**Oxley Solar Farm**

# Submissions Report

Proposal Number: 21-393

Figure 3-4 Updated development footprint compared to the EIS development footprint

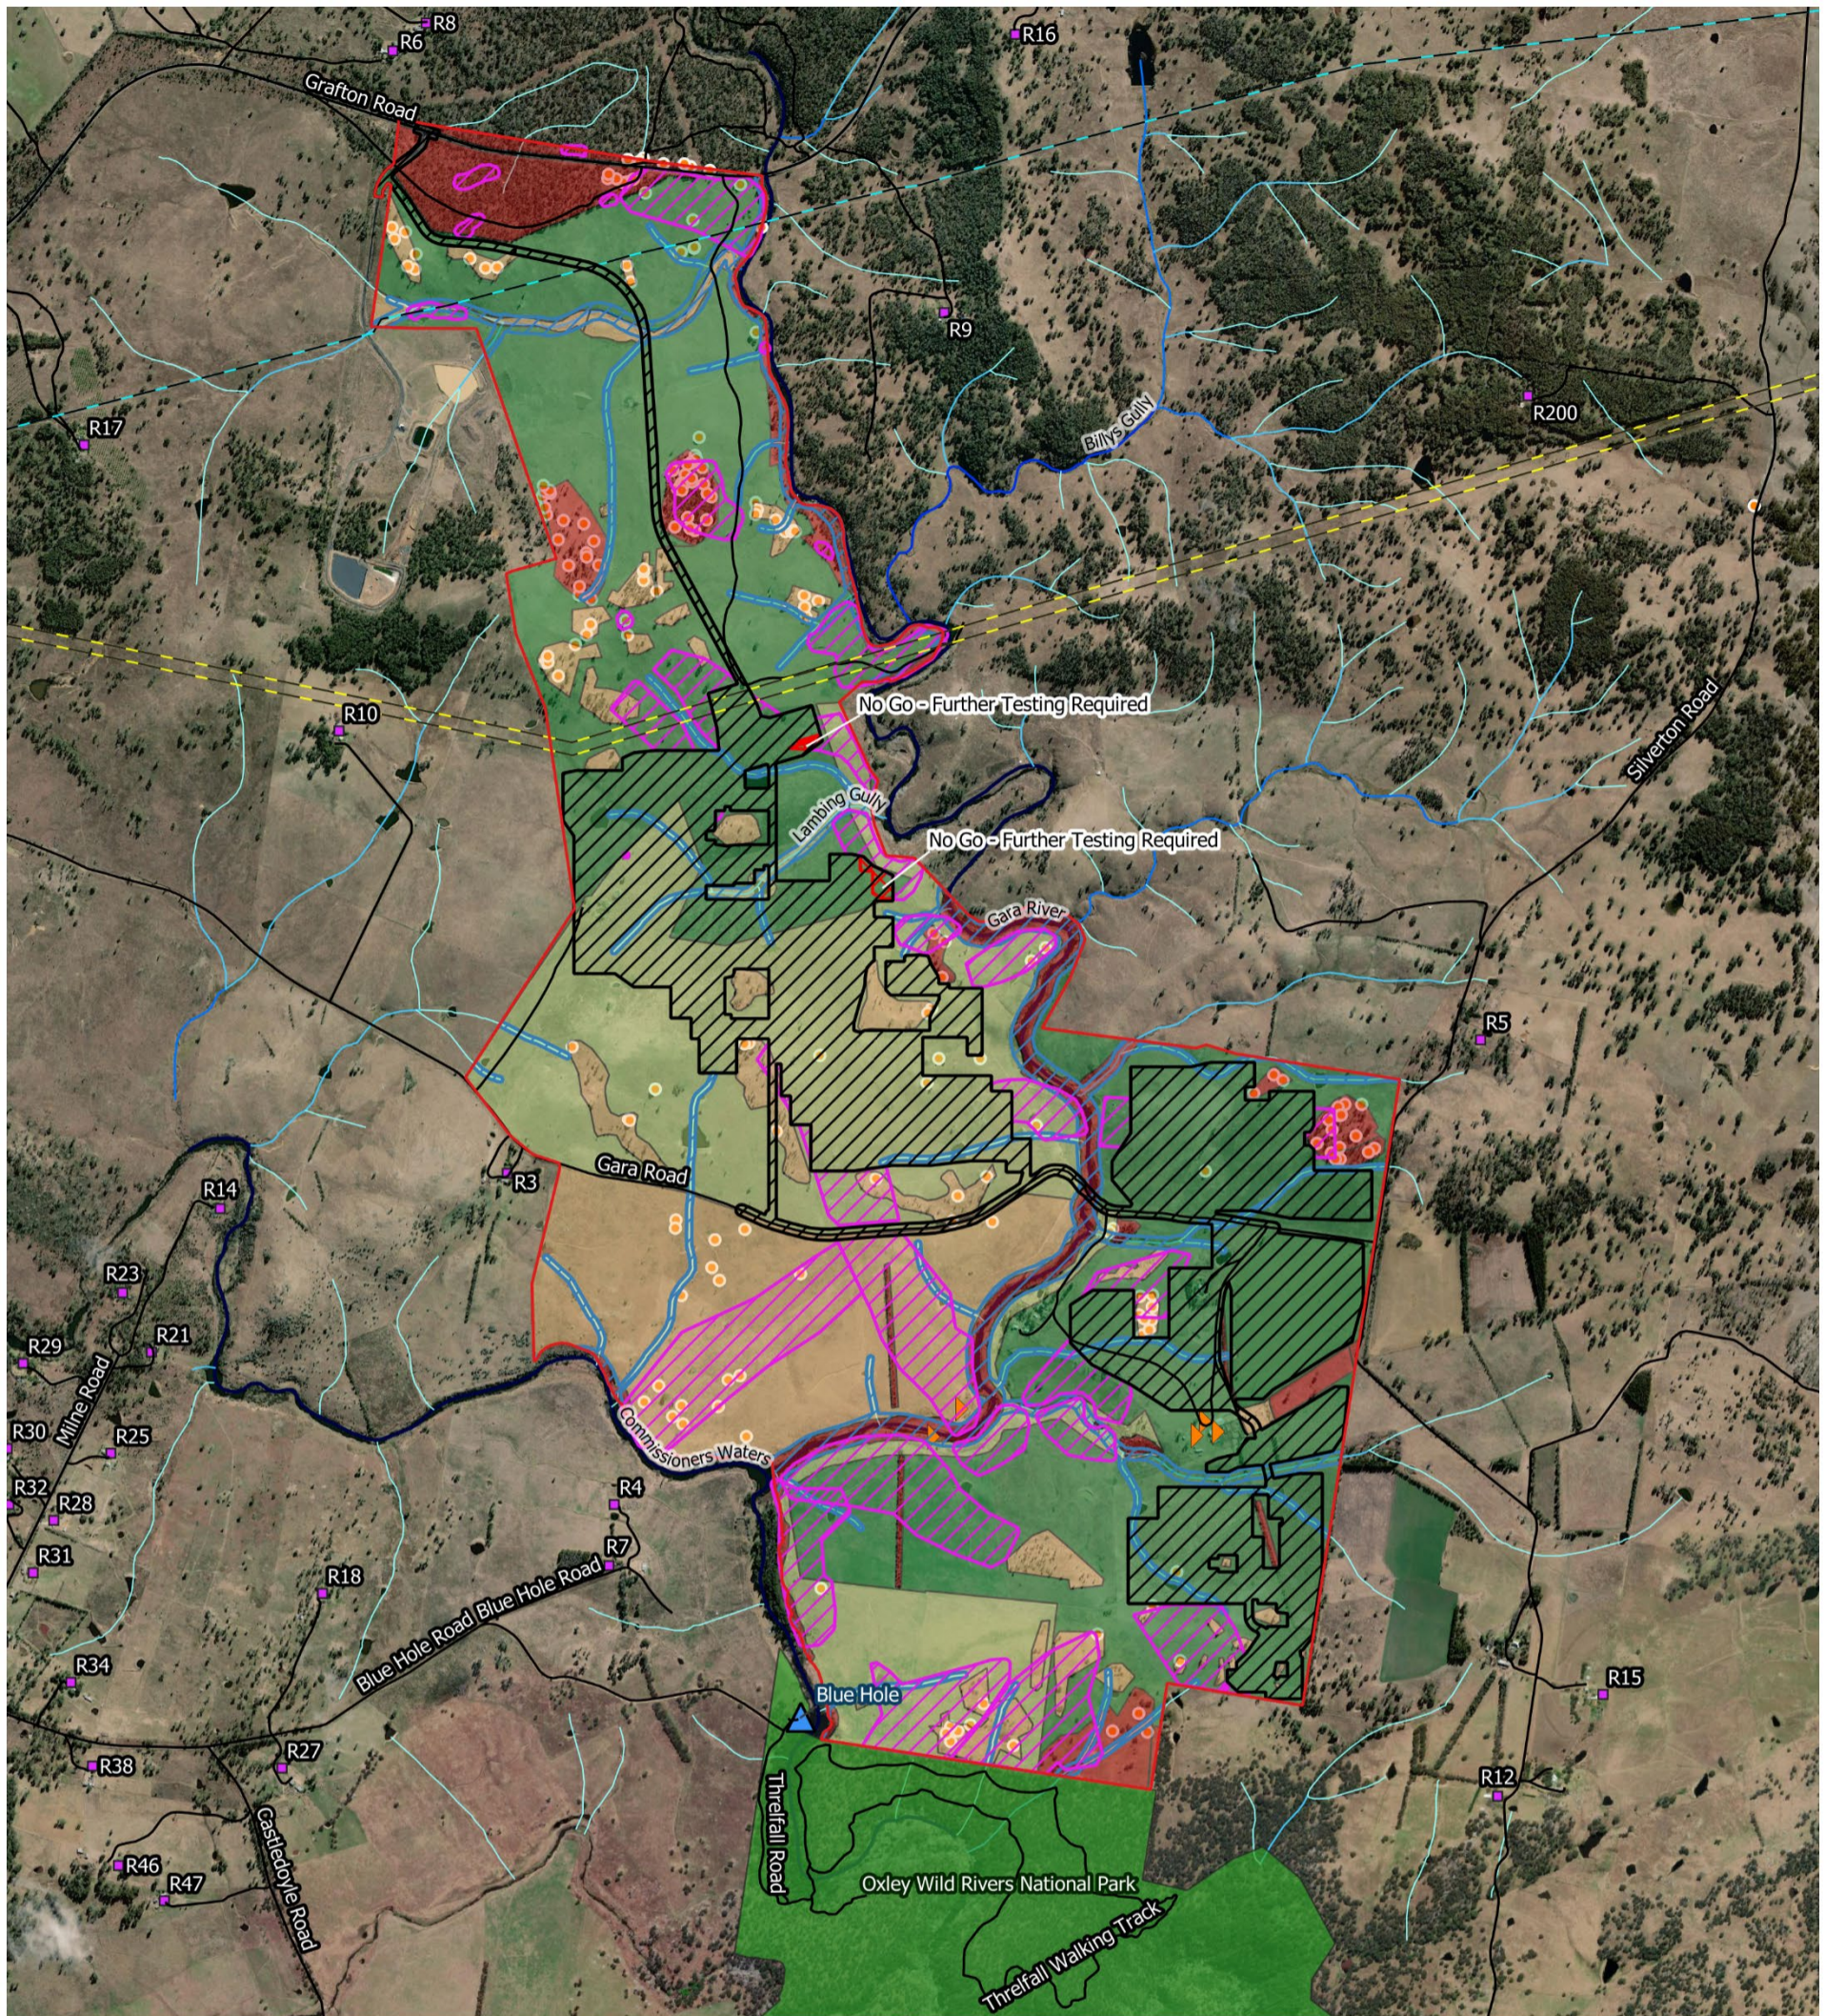
Issue	Number of submissions	Detail of issue	Proponent Response
		 <p>Figure 4-4 View points and dwellings assessed southwest of the proposal.</p>	<p>Siltation of the Blue Hole and potential long term erosion impacts to the Oxley Wild Rivers National Park</p> <p>Recreational areas such as the Blue Hole picnic area are of high importance to the local community. In consideration of the level of community concern, significant changes to the Development footprint now include increased setbacks from Blue Hole within Oxley Wild Rivers National Park, as above. The</p>

Issue	Number of submissions	Detail of issue	Proponent Response
			<p>setback has increased to distance of Blue hole from the nearest solar array from 500m to over 1.2km. Refer to Figure 3-4.</p> <p>However, while solar farms require ground disturbance, landform reshaping is only required for access tracks and discrete footing areas. The majority of the Development footprint will be impacted only by the screw in piles for the solar panel mounts and the shading of the panels themselves would only impact 75% of the Development footprint. The highest risk activities for soils and waterways are where cabling and tracks must cross waterways; these areas would be very limited. Waterway infrastructure works would be limited to the causeway along Gara Road. The crossing would be constructed in consideration of the following guidelines and is likely to improve the condition of the Gara River at this site as it would be transformed from a wet crossing (multiple vehicle crossings per day that would track sediment through the River) to a formalised culvert:</p> <ul style="list-style-type: none"> <li>• Guidelines for Watercourse Crossings on Waterfront Land (DPIE , 2012)</li> <li>• Guidelines for Laying pipes and Cables in Watercourses on Waterfront Land (DPI, 2012)</li> <li>• <i>Why do fish need to cross the road? Fish Passage Requirements for Waterway Crossings</i> (Fairfull &amp; Witheridge, 2003)</li> <li>• <i>Policy and Guidelines for Fish Friendly Waterway Crossings</i> (DPI, 2003)</li> </ul> <p>Risks of these works are minimised by the implementation of a Soil and Water Management Plan (a draft has been prepared as Attachment C). Additionally, a Ground Cover Management Plan and Erosion and Sediment Control Plan will further manage and minimise potential impacts and form commitments of the Proposal.</p>

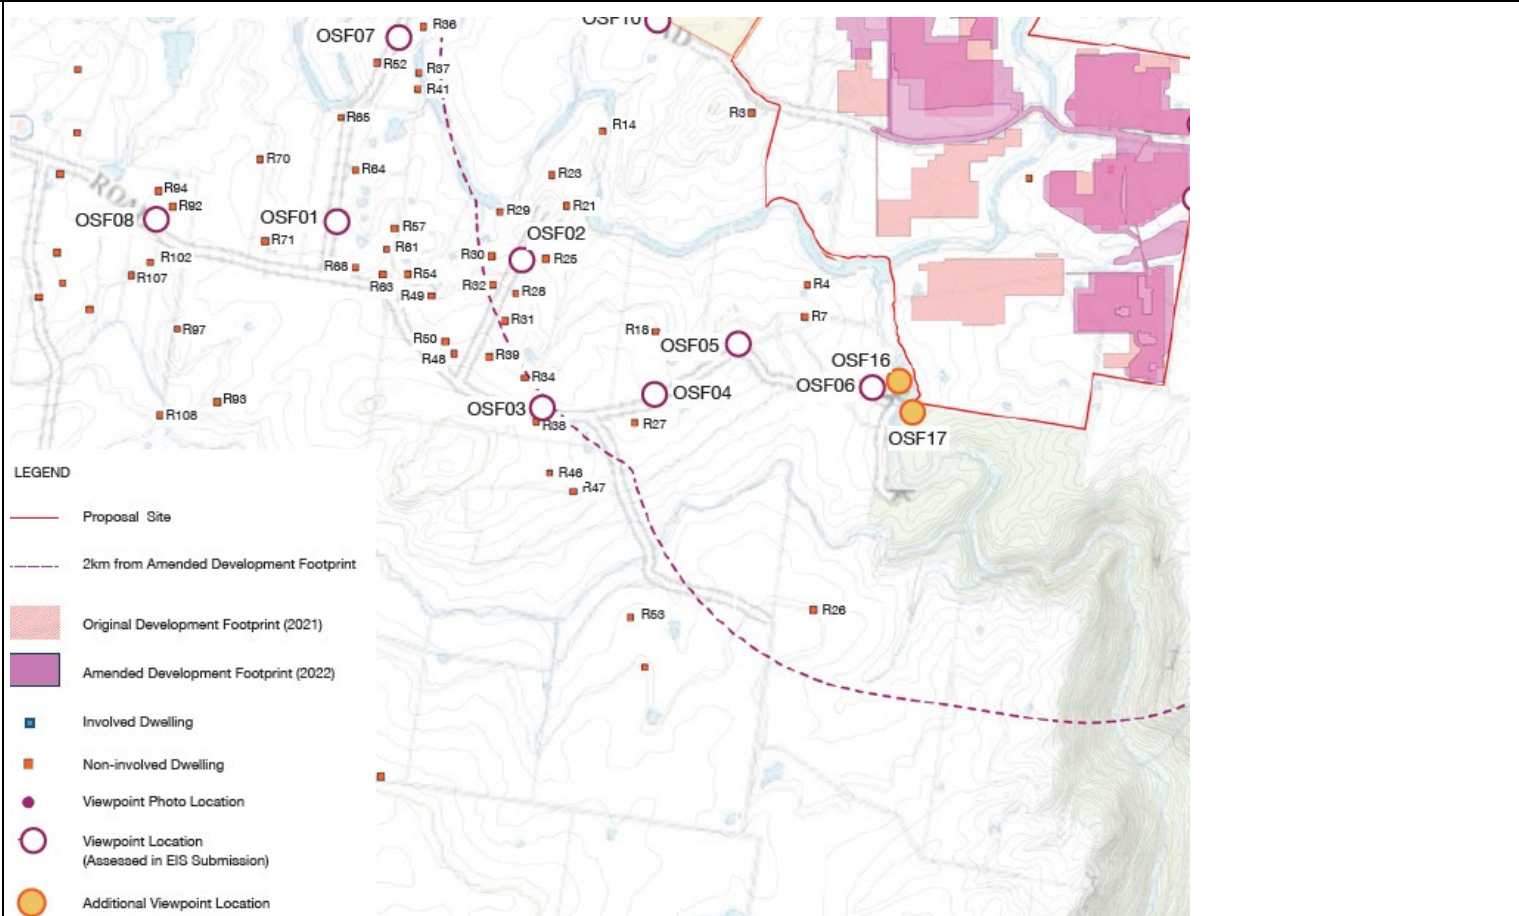
Issue	Number of submissions	Detail of issue	Proponent Response
			<p>An updated Landscape plan has been prepared and has screen planting proposed on the southern project boundary, adjacent the to the National Park (Figure 4-3). Impacts on park usage and tourism value are therefore expected to be minimal.</p>  <p>Figure 4-1 View from Blue Hole Picnic Area (Oxley Wild Rivers National Park) OSF16</p>

Figure 4-6 Measures of air temperature within and outside of the PV array (Barron-Gafford Research Group , 2018)

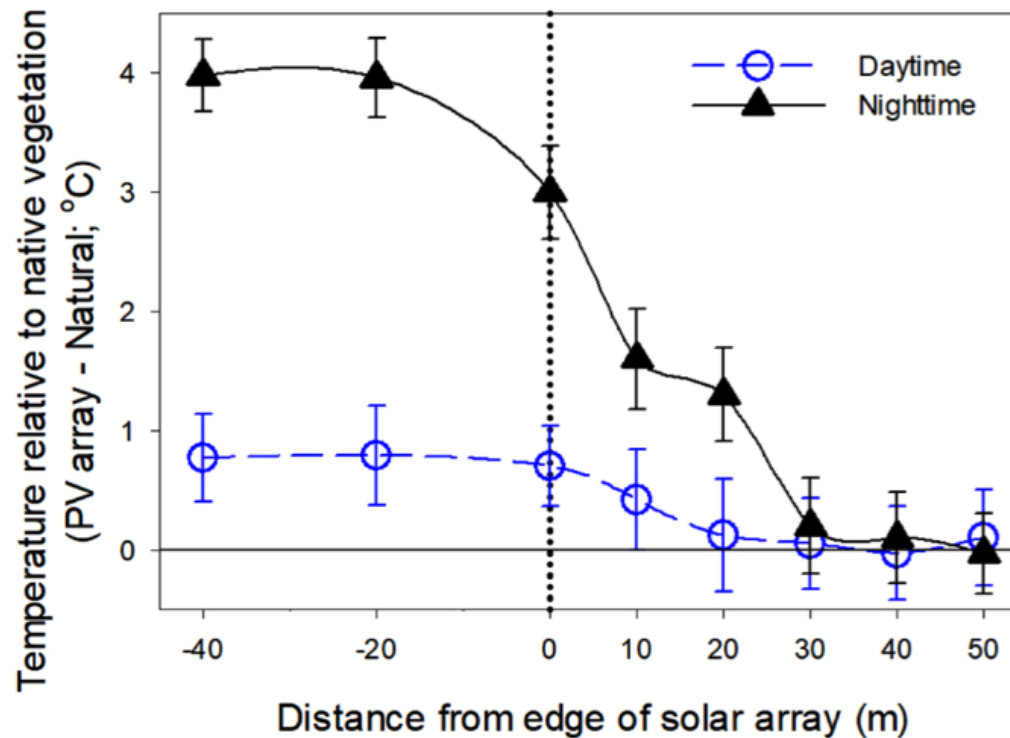
Issue	Number of submissions	Detail of issue	Proponent Response
-------	-----------------------	-----------------	--------------------

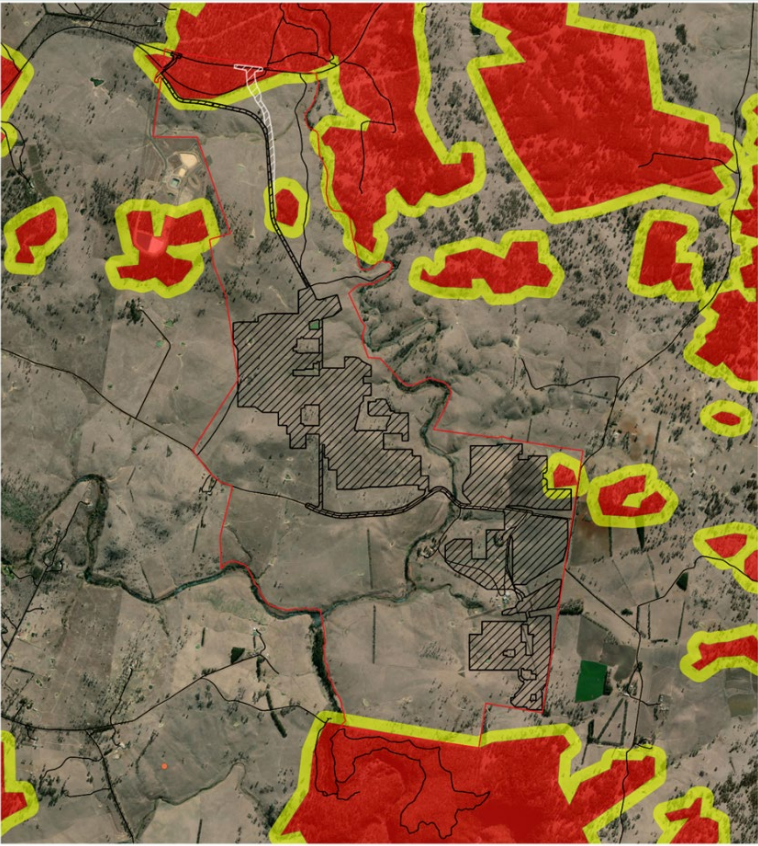
<b>Environmental, social and economic impacts</b>		
Visual Amenity	<p>The Action group raised concerns over the possible visual amenity impacts of the Proposal, including:</p> <ul style="list-style-type: none"> <li>Any objective site assessment will confirm the Proposal will induce significant de-valuation of the landscape characteristics not only from the neighbouring properties but also the broader community.</li> <li>The EIS in the absence of LVIA guidelines introduces their own subjective assessment of the impact including construction and operation. In support of the Developer’s attempt to promote a subjective and favourable reflection they introduce Moir Landscape Architecture Pty Ltd an interpretation of the LVIA</li> </ul>	<p>There are no statutory guidelines for the assessment of visual impact of solar farms. The assessment references the <i>Guidelines for Landscape and Visual Impact Assessment (GLVIA3)</i>, <i>Residential Visual Amenity Assessment (RVAA)</i>, considered best practice, and Moir LA’s extensive professional experience in undertaking landscape and visual assessments for infrastructure projects, including solar farms. It also considers draft guidelines developed to guide visual assessment of solar farms, now specifically considering key issues such as glare, elevated views and multiple sector views; <i>Appendix A – Visual Assessment Framework for Large-Scale Solar Energy Development</i> – of DPE’s <i>Draft Large-Scale Solar Energy Guidelines</i> (DPE, 2021).</p> <p>The assessment considers public viewpoints to assess impacts on roads and from the National Park, Appendix A of the full updated visual assessment includes seven montages taken from or near to dwellings to show how the infrastructure would look from specific residences.</p> <p>It is acknowledged that visual assessment can be a subjective area. To that end, Moir Landscapes are a reputable specialist in this area and have undertaken numerous solar</p>

Issue	Detail of issue	Proponent response
	<ul style="list-style-type: none"> <li>The bottom line is, as DPIE fully appreciate, that LVIA is probably the most malleable assessment in the EIS process. Developers can manipulate interpretations of landscape character assessment to suit development agenda. In this case the Developer has pursued viewpoint analysis which is dramatically different than the reality</li> <li>It has misrepresented through subjective, facile and superficial interpretation of community feedback the significant visual impact this Development will induce to the character of the landscape. A landscape appreciated by immediate Community and the broader Community.</li> <li>It has selected viewpoints convenient to its development interests – whereas there are many others which paint a more realistic outlook.</li> <li>It has utilised photographic misrepresentation including zoom images and panoramic images which distort rather than reveal the true landscape value and character.</li> <li>The suggestion that some residences will have fragmented views of the development is a poor attempt to disguise the reality of the outlook.</li> </ul> <p>Accordingly, the Group welcomes a DPIE inspection of the true visual impact. On this basis</p>	<p>farm visual assessment as well as provided comment on the new guidance documents.</p> <p>There are no statutory guidelines for the assessment of visual impact of solar farms. The assessment references the <i>Guidelines for Landscape and Visual Impact Assessment (GLVIA3)</i>, <i>Residential Visual Amenity Assessment (RVAA)</i>, considered best practice, and Moir LA’s extensive professional experience in undertaking landscape and visual assessments for infrastructure projects, including solar farms.</p> <p>While public viewpoints were used to assess impacts on roads and from the National Park, Appendix A of the full updated visual assessment includes seven montages taken from or near to dwellings to show how the infrastructure would look from these residences. The wireframes are helpful for showing how the terrain affects the views and fragments them.</p> <p>In consideration of the undulating terrain, the existing vegetation screening, set back distances now achieved and the low profile of the infrastructure proposed, we feel confident a peer review of MLA’s conclusions will support their conclusions.</p>  <p>Figure 4-7 Example wireframe modelling, superimposed on panoramic image</p>
